HISTORIC PRESERVATION COMMISSION

Historic Area Work Permit #480418 - Removal of rear addition, construction of rear addition,

MONTGOMERY COUNTY HISTORIC PRESERVATION COMMISSION STAFF REPORT

NIEMCZEWSKI/HOFFMAN RESIDENCE 6 E. IRVING STREET CHEVY CHASE, MD 20815

EAST ELEVATION

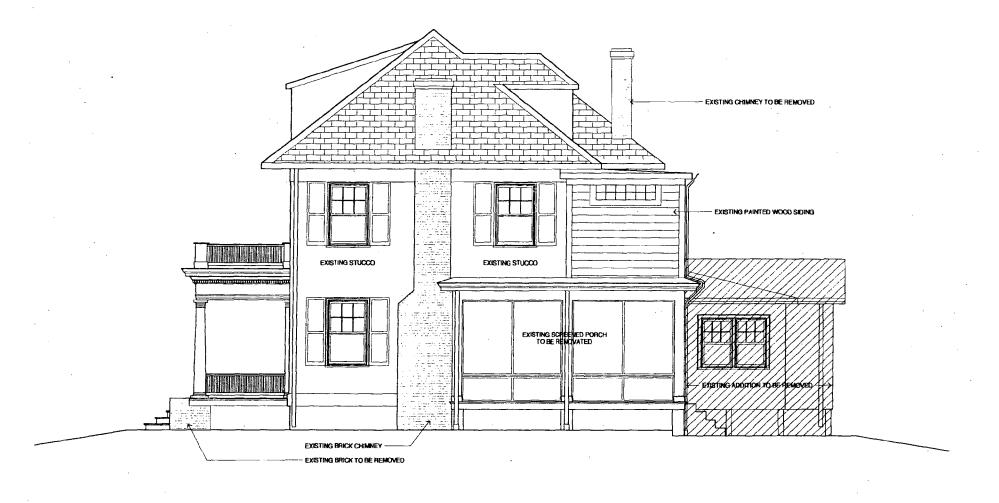
- 5. On the east elevation, what is the purpose of the stone wall that runs up the side of the house and above the roof? It's not a chimney, but what is it?
- 6. On the east elevation--what is the "existing window relocated from east wall"? Is this currently an interior window? Possibly original to the house?
- 7. I see there are shutters in the proposed east elevation that are not shown in the existing—are they proposed wood, operable shutters? Do you believe there were originally shutters on the side of this house?
- 8. Are the sliding barn doors in the pool house wood?
- 9. Do you know if your clients have run the large outdoor fireplace by their neighbors yet?

- 4. I do not have a rendering at the moment, if we need to I'll come up with one.
- 5. The stone wall is a compositional element to end the window fenestration at the back. We thought that would minimise the visual impact from the street.

- 6. That is an existing window internal to the existing porch. I think it is existing to the house. It is not currently visible from the street.
- 7. There are shutters existing on the east side, we want to keep them. They will be repainted. I'll send a picture (dscn2871 enclosed).

WEST ELEVATION

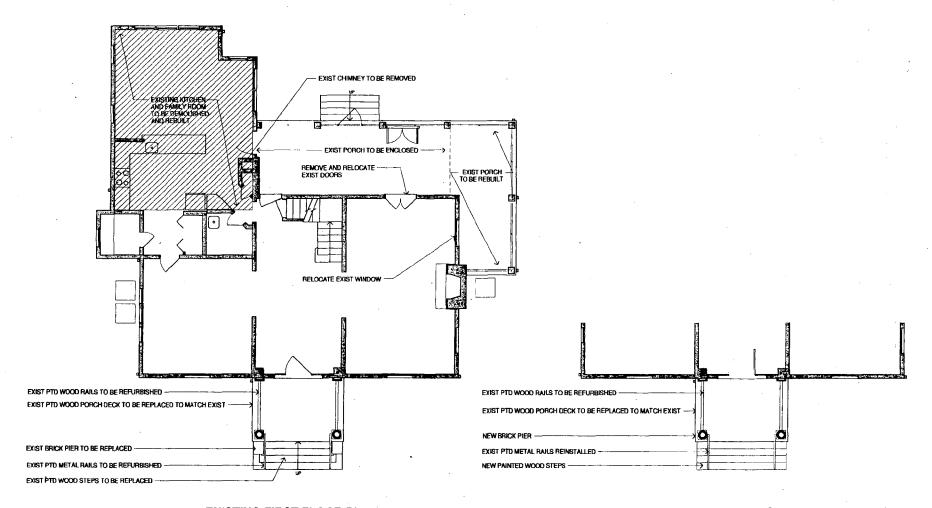
- 1. What is the material of the new basement door?
- 2. Do you have a photo of the west elevation you can send me?
- 3. I asked Trish for this but I will ask you too—I need the dimensions of the outdoor stone fireplace. Is there a reason it needs to be that height?
- 4. Do you have any sort of rendering (or oblique view) that better shows the wood trellis/terrace feature? thanks,

- 1. The basement door will be wood
- 2. I'll go through what I have and either enclose it with this (see pictures enclosed) or go and take a new photo, It's kind of tight there is a tree in the way.
